**PA-2017-00978**  
**232 Nutley**

**Packet information submitted at the  
October 10, 2017 PC Meeting**

**PLANNING ACTION:** PA-2017-00978

**ASHLAND PLANNING DEPARTMENT  
STAFF REPORT**

Barn

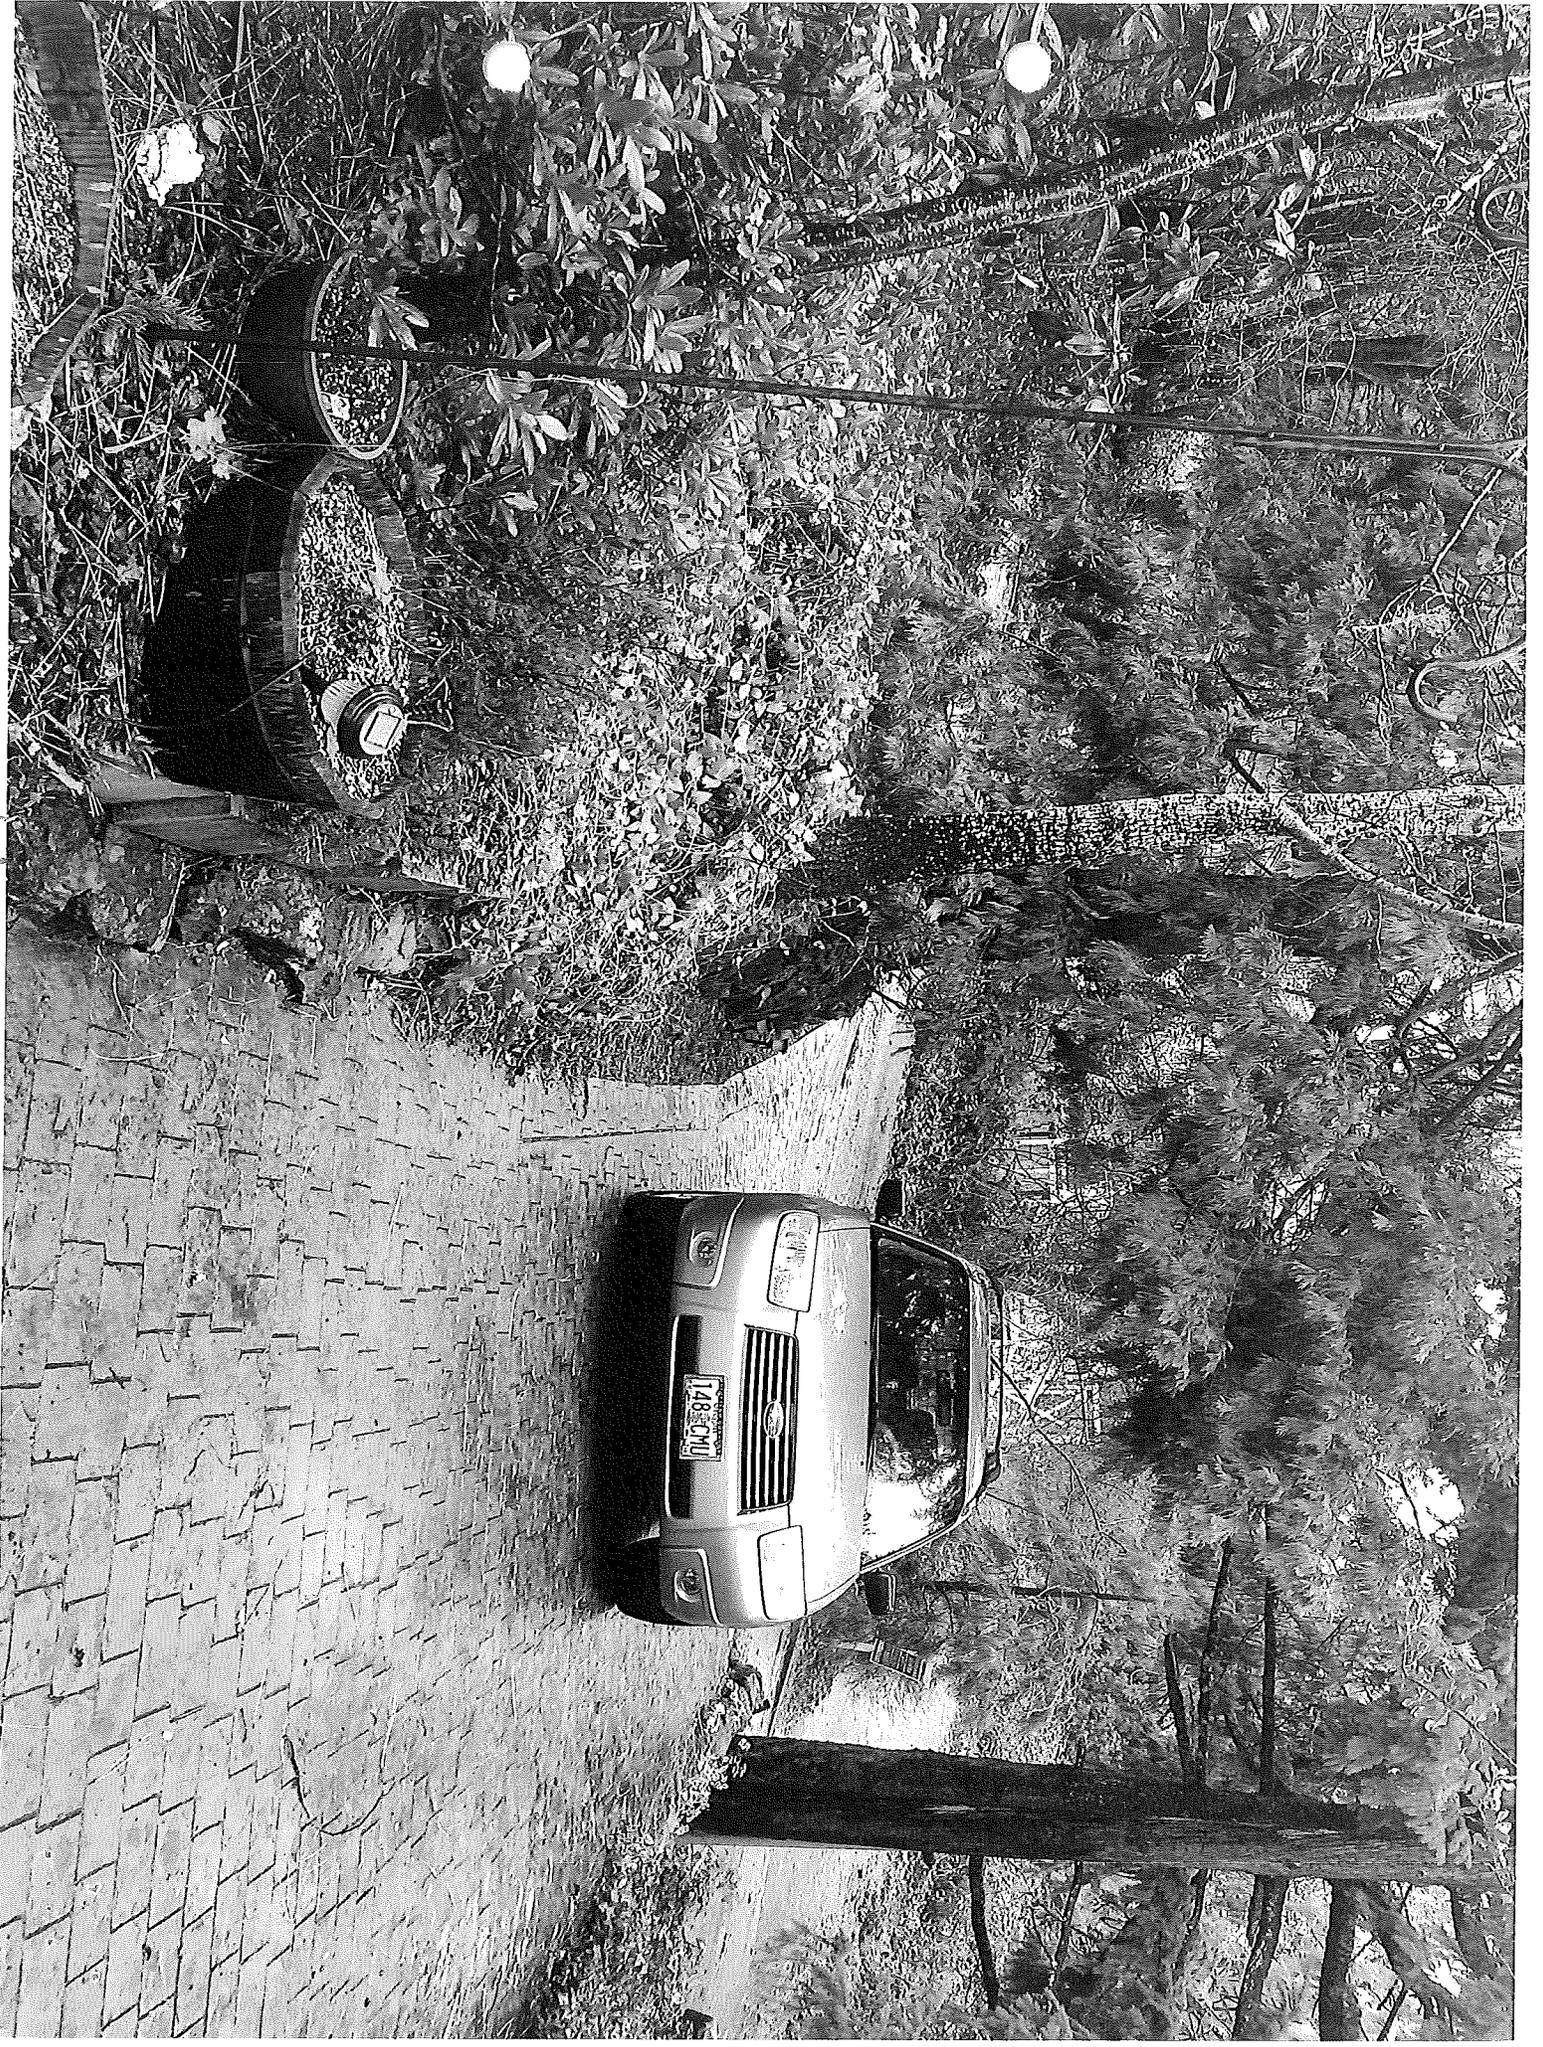
AREA OF  
CONVERGING APRONS  
FOR 151 ALNUTY  
AND THE PROPOSED  
ARU'S EXIT

AREA OF  
CONVERGING APRONS  
FOR 151 ALNUTT  
AND THE PROPOSED  
ARU'S EXIT

A "PARKING  
SPACE" WITH  
NO WHERE  
TO GO

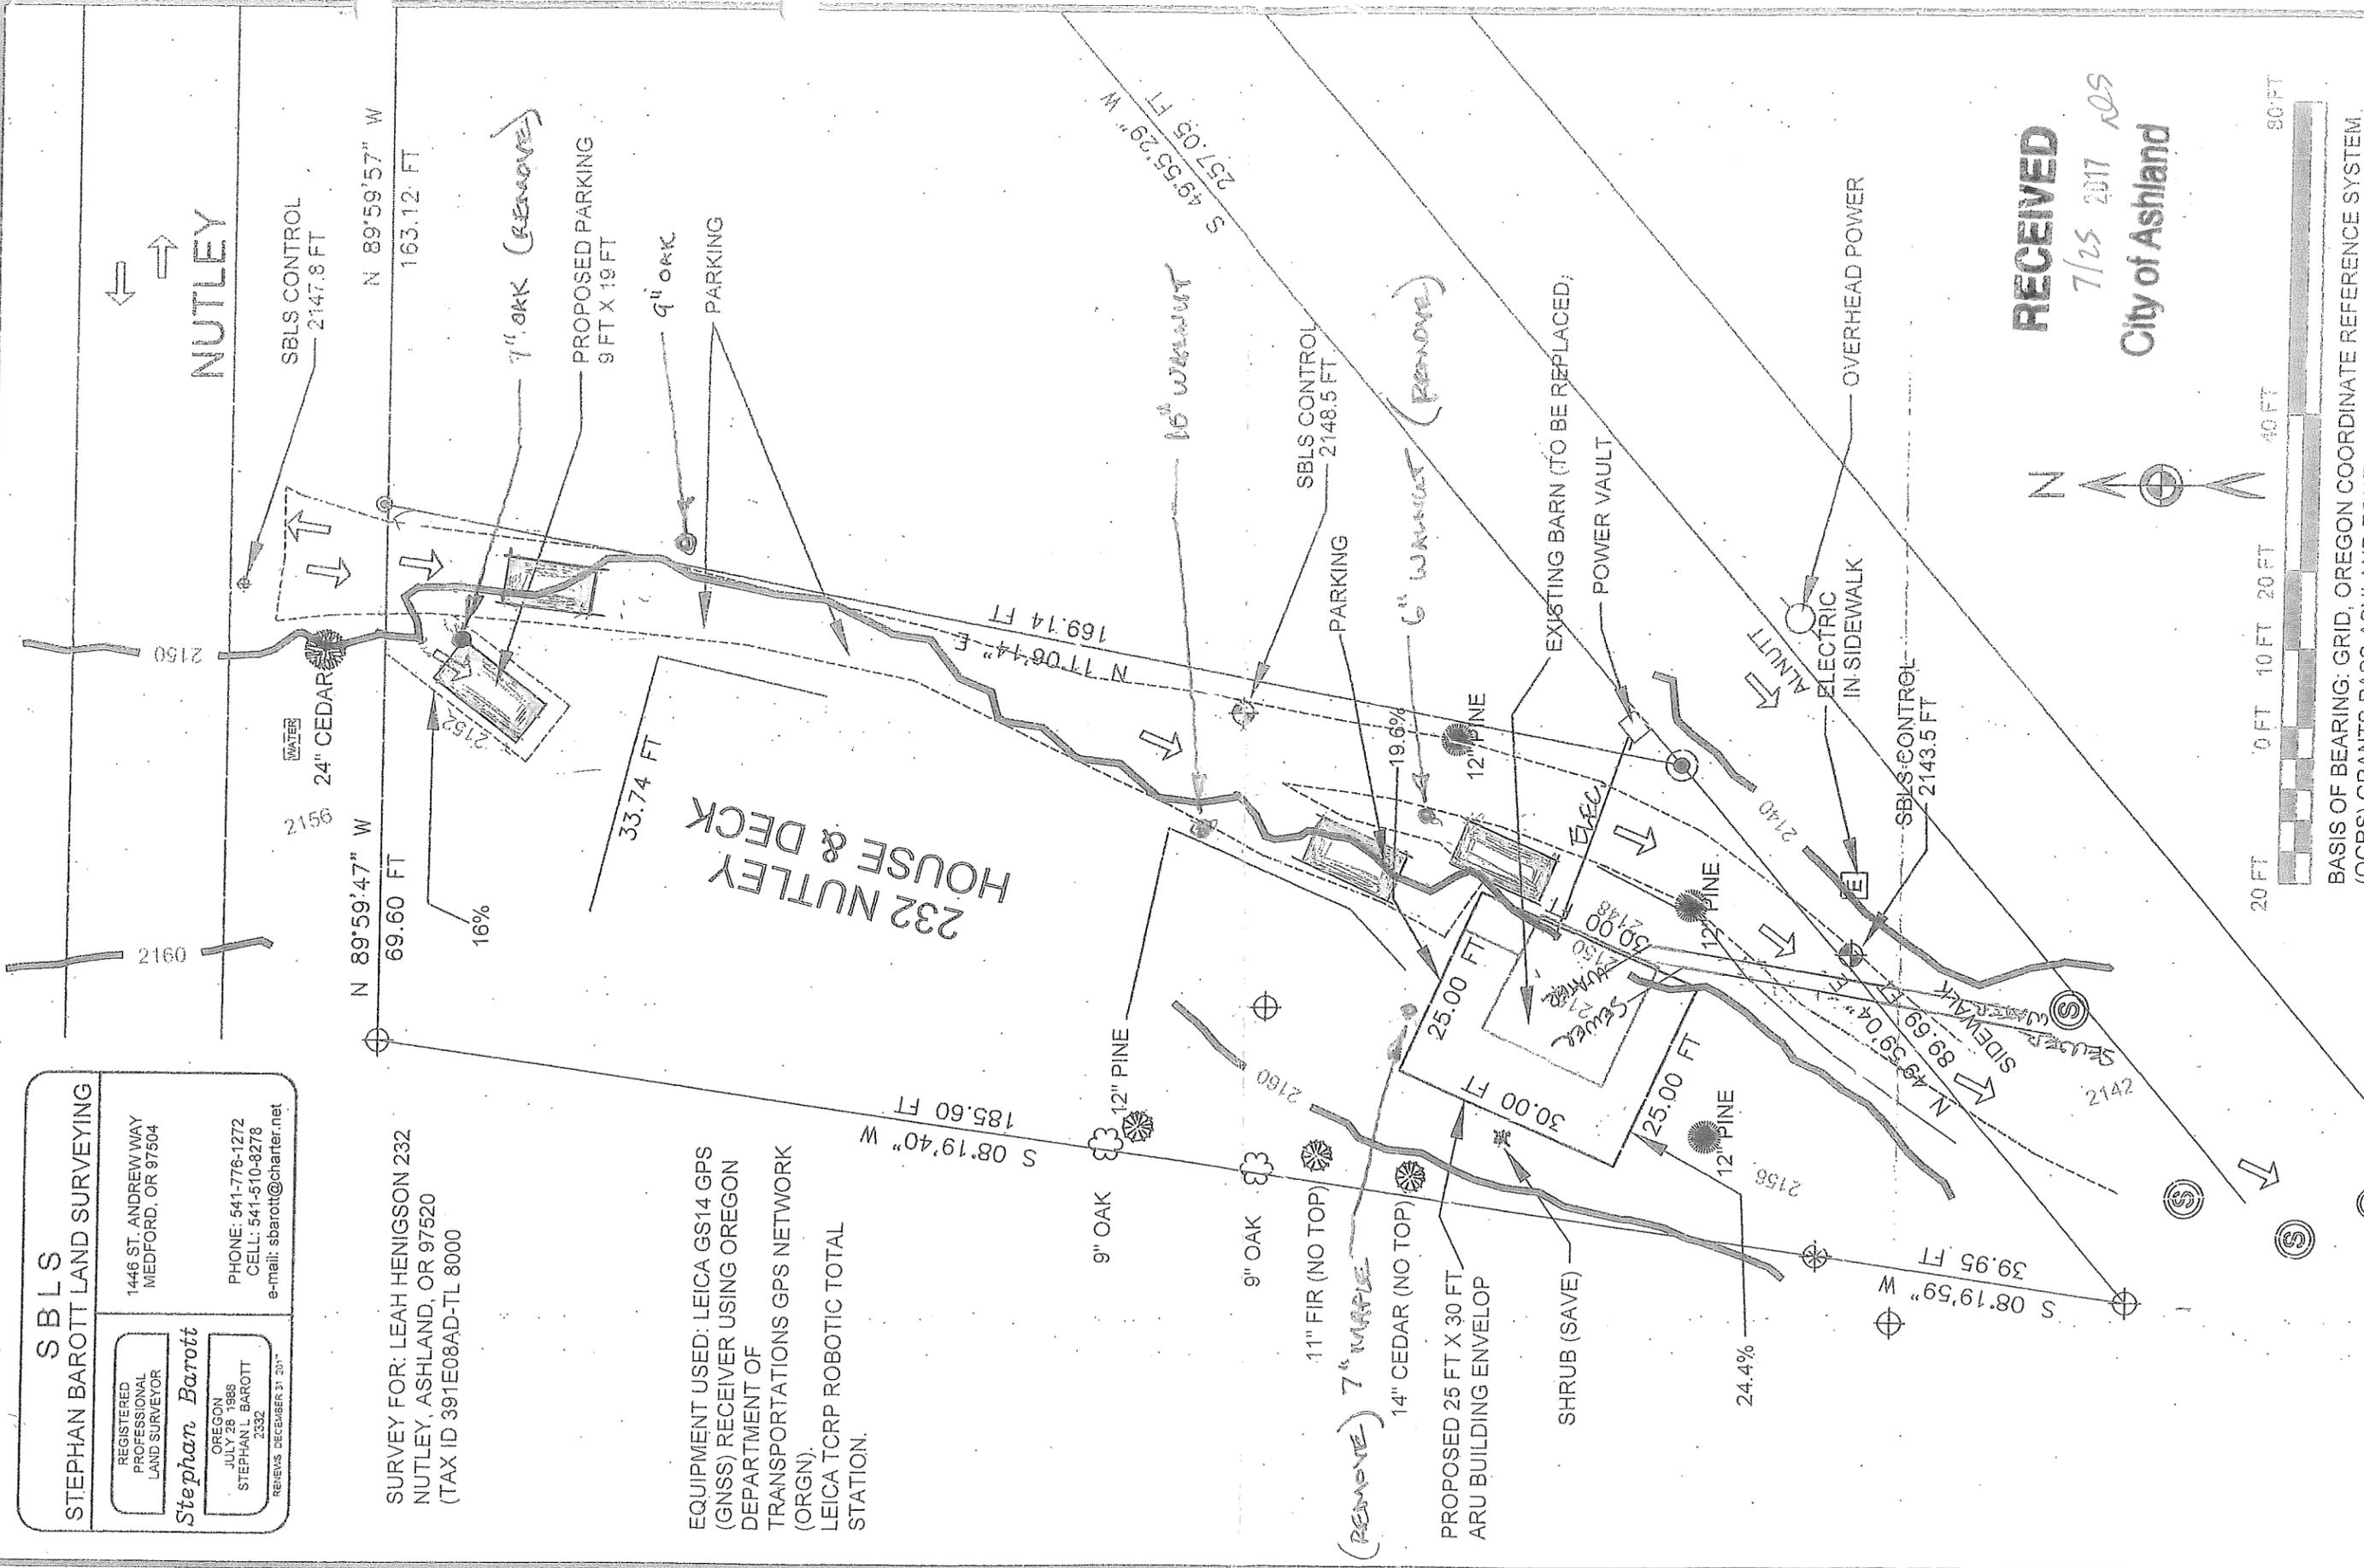
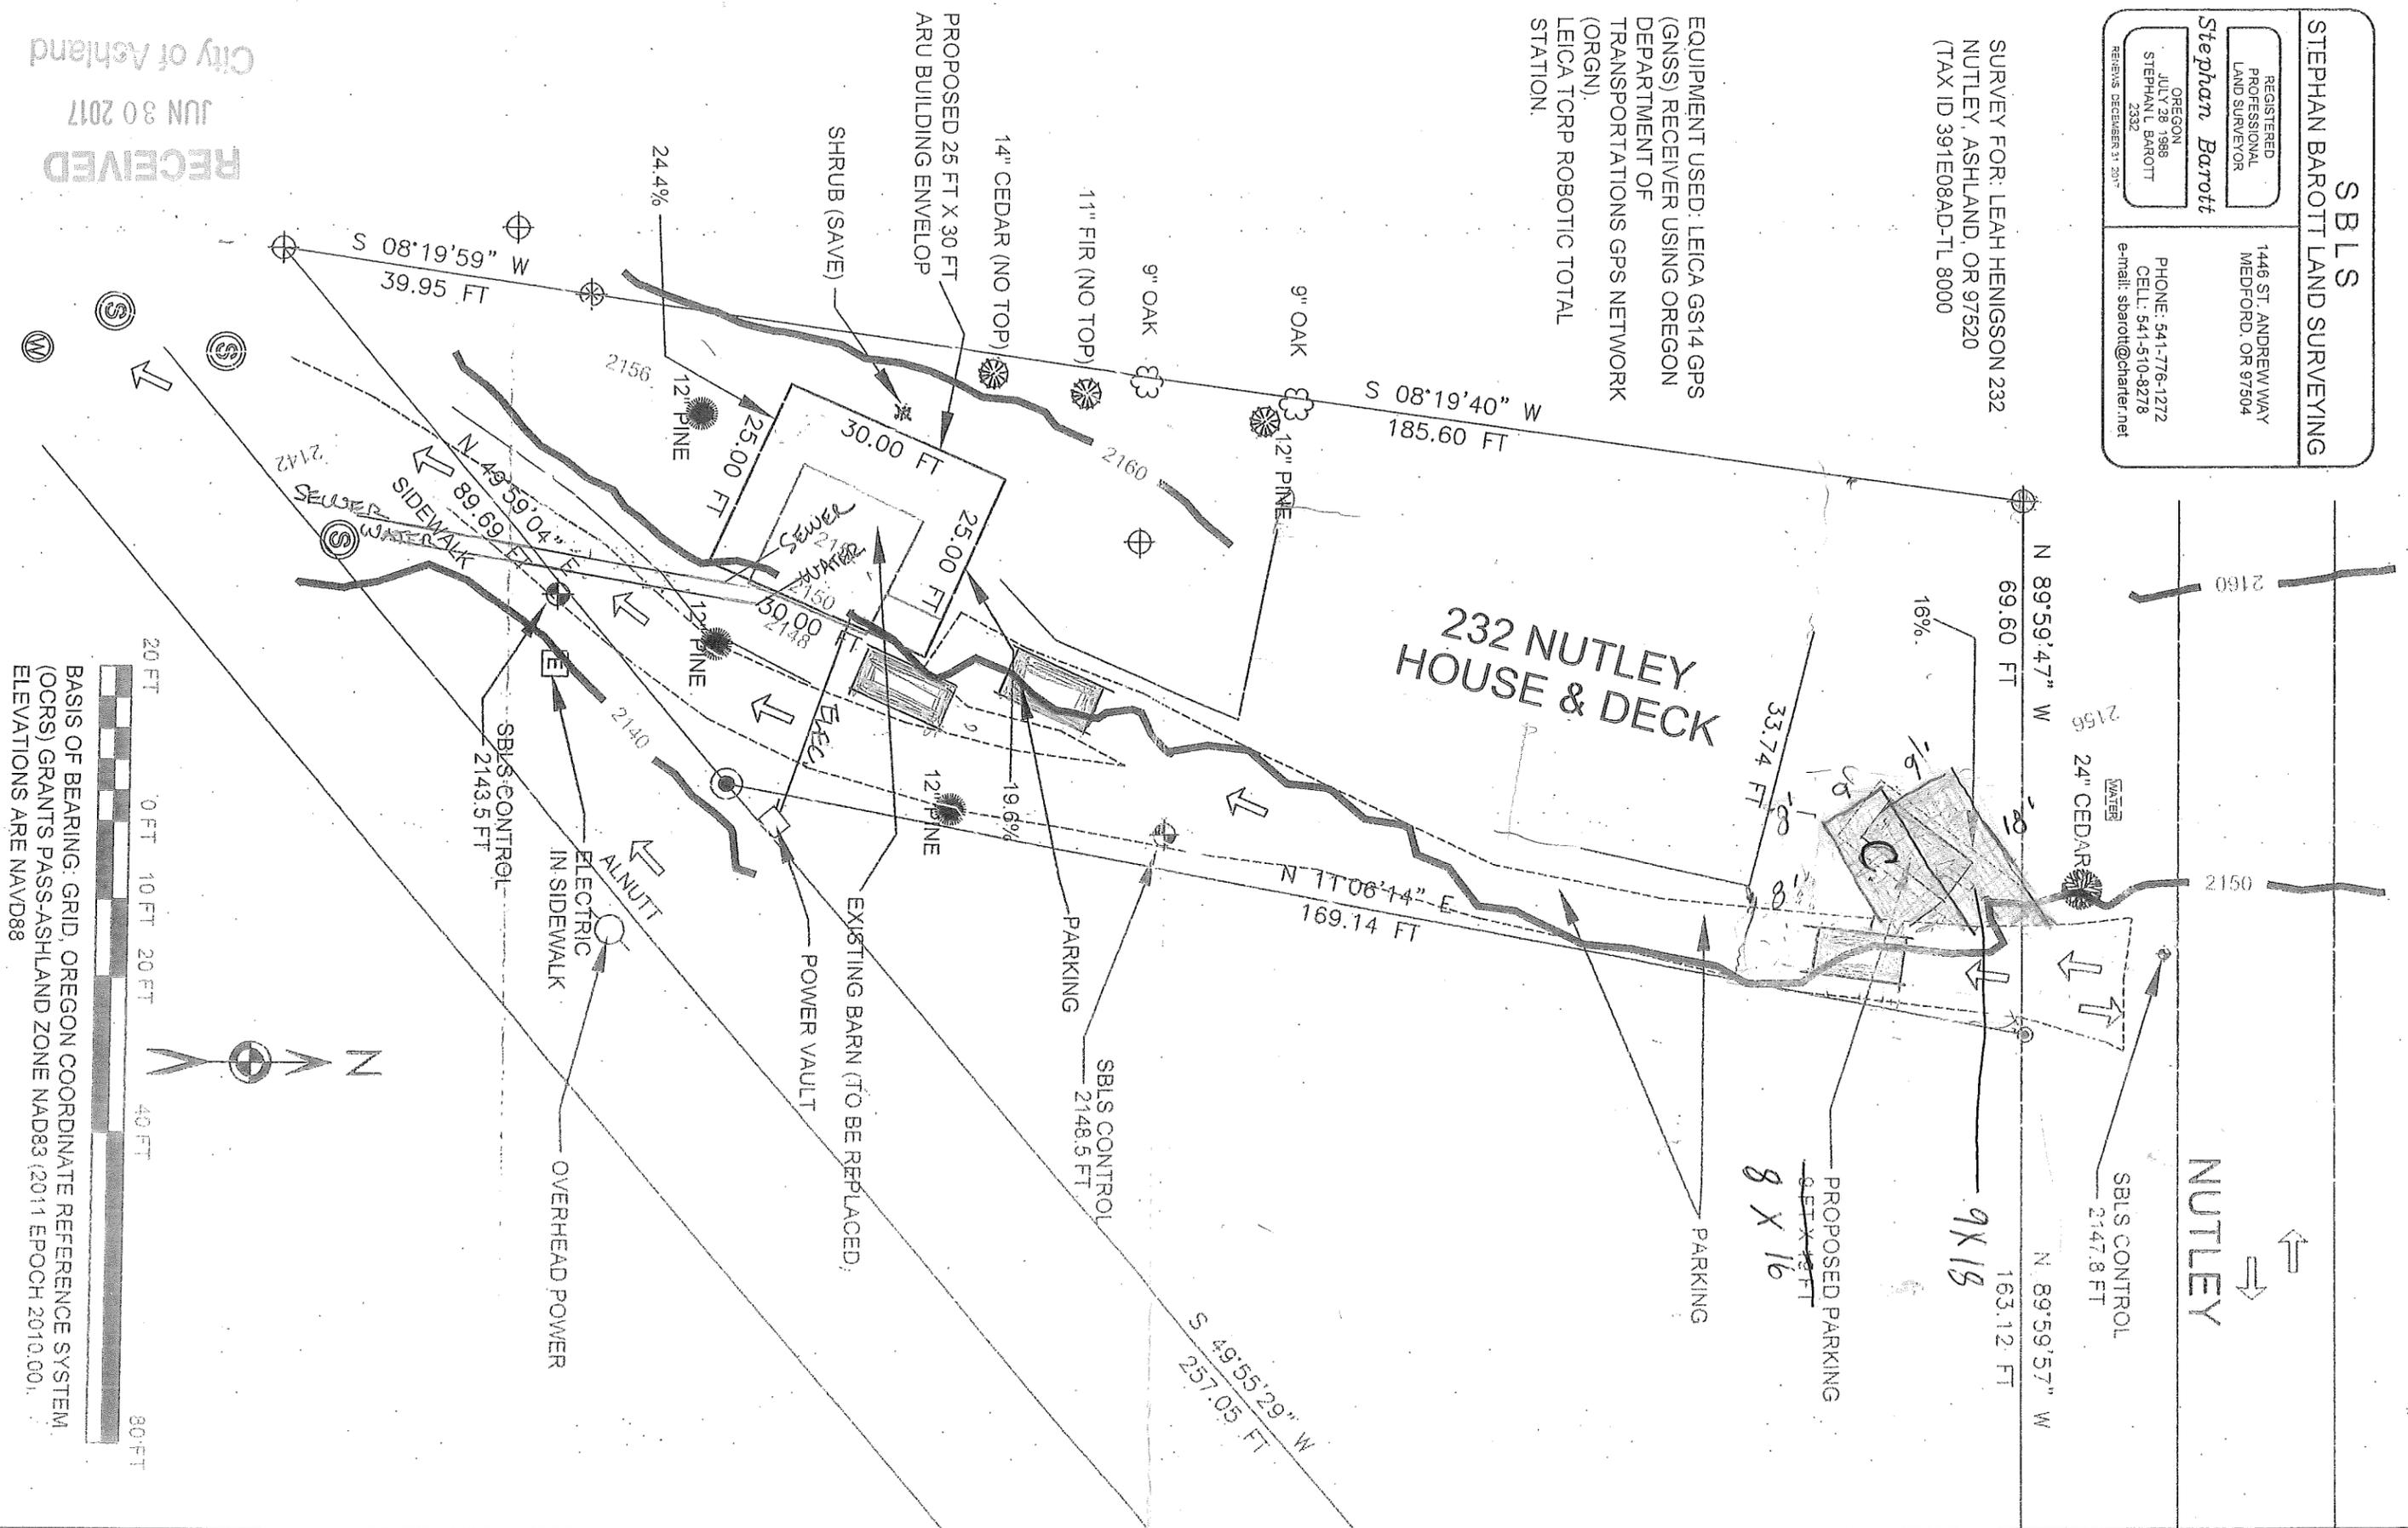
In reviewing the Site and Floor Plans provided, staff have noted that a small triangular area of the deck and a small triangular area of the unit extend into the required rear yard setback

at the southeast corner of the site near Alnutt Street. A condition was added to the original staff approval and is again recommended below to require that the footprint and floorplan be adjusted to address the required setback, and that the property line, setback and footprint be marked on site for verification prior to the issuance of a building permit.

The site plan prepared by applicant’s surveyor, Stephan Barott, indicates a corner of the ARU as a 24.5% slope. What methods and surveying techniques did he use to arrive at that convenient percentage? There is no “slope analysis” which is required under Ashland Municipal Code. 18.3.10(K). A proper slope analysis would reveal the actual **natural slope** of the subject property to be greater than 25%. The surveyors map uses 10 foot intervals, but is required to have 2 foot intervals for showing actual natural slope. 18.3.10 (K). In 2012, in a pre-application document for the same ARU, the city stated that the slope on the subject property was “greater than 25% slope” and required a slope analysis. This property is located in the Hillside Development area. While the area where the barn is currently located has been excavated and leveled, the 25% slope requirement is that the natural slope is not greater than 25% not just the buildable envelope. Anyone can see on a site visit, that the natural slope was excavated creating an unretained cut bank uphill from the barn. The excavated dirt was then pushed out to level the pad where the barn sits. The applicant proposes to build an ARU three times the size of the existing barn, remove numerous mature trees to fit it in and all without disturbing the soil? The City of Ashland’s Physical and Environmental Constraints, Hillside Lands and Severe Constraints map shows that the subject property falls into the Hillside Lands area, and more importantly, the portion alongside Alnutt is colored as an area of “Severe Constraints (>35% slope). If a person stands at the boundary line fence between Patricia Zolene’s property at 240 Nutley, and the Applicant’s property, and looks down to Alnutt past the existing barn, the natural slope of the land is very apparent, and obviously very steep. Because the ARU is proposed on Hillside Land with slopes that exceed 25%, it cannot be built there under the City code.

- c. The building plans shall be adjusted to remove any intrusions into the required setbacks. The property line abutting Alnutt Street, the required setbacks, and the adjusted proposed building footprint shall be identified on the property, inspected and approved by the Staff Advisor.
